ADA Curb Ramp New Construction Inspection Form (Parallel)

Main	24952.54			Commercial	
North-South Road Name	Project No.	Sheet No.	Intersection No.	East-West Road Name	See https://www.oregon.gov/odot/Engineering/Documents_RoadwayEng/ADA_ExhibitA.pdf for more corner styles. Use Washington County corner numbering system.
Calibration Date 10/8/2024 (mm/dd/yy)

PARALLEL RAMP (PL)

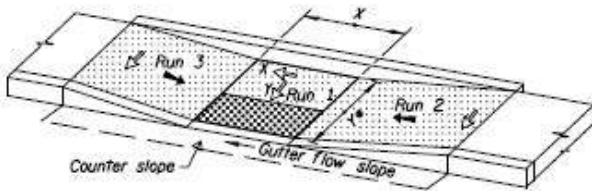
RAMP RUN 1		Pass	Fail
Running Slope 1	7.7 ≤ 2.0% <input type="checkbox"/> > 2.0% <input checked="" type="checkbox"/>		
Cross Slope 1	<input type="text"/> ≤ 2.0% <input type="checkbox"/> > 2.0% <input type="checkbox"/>		
Detectable Warning	N Y <input type="checkbox"/> N <input checked="" type="checkbox"/>		
Lip Height	0 ≤ 1/4" <input checked="" type="checkbox"/> > 1/4" <input type="checkbox"/>		
Gutter Flow Slope	3.9 ≤ * <input type="checkbox"/> > * <input checked="" type="checkbox"/>		
Curb Running Slope (avg)	<input type="checkbox"/> 4.08 ≤ 8.3% <input checked="" type="checkbox"/> > 8.3% <input type="checkbox"/>		
Counter Slope (+/-)*2	8.3 ≤ 5.0% <input type="checkbox"/> > 5.0% <input checked="" type="checkbox"/>		
Det. warning full width of ramp	<input type="text"/> Y <input type="checkbox"/> N <input checked="" type="checkbox"/>

RAMP RUN 2		Pass	Fail
Running Slope 2	<input type="text"/> ≤ 8.3% <input type="checkbox"/> > 8.3% <input type="checkbox"/>		
Length 2	7.4 <input type="text"/>		
Cross Slope 2	14.3 ≤ 2.0% <input type="checkbox"/> > 2.0% <input checked="" type="checkbox"/>

RAMP RUN 3		Pass	Fail
Running Slope 3	<input type="text"/> ≤ 8.3% <input type="checkbox"/> > 8.3% <input type="checkbox"/>		
Length 3	7.3 <input type="text"/>		
Cross Slope 3	13.3 ≤ 2.0% <input type="checkbox"/> > 2.0% <input checked="" type="checkbox"/>

No Td. Asphalt.
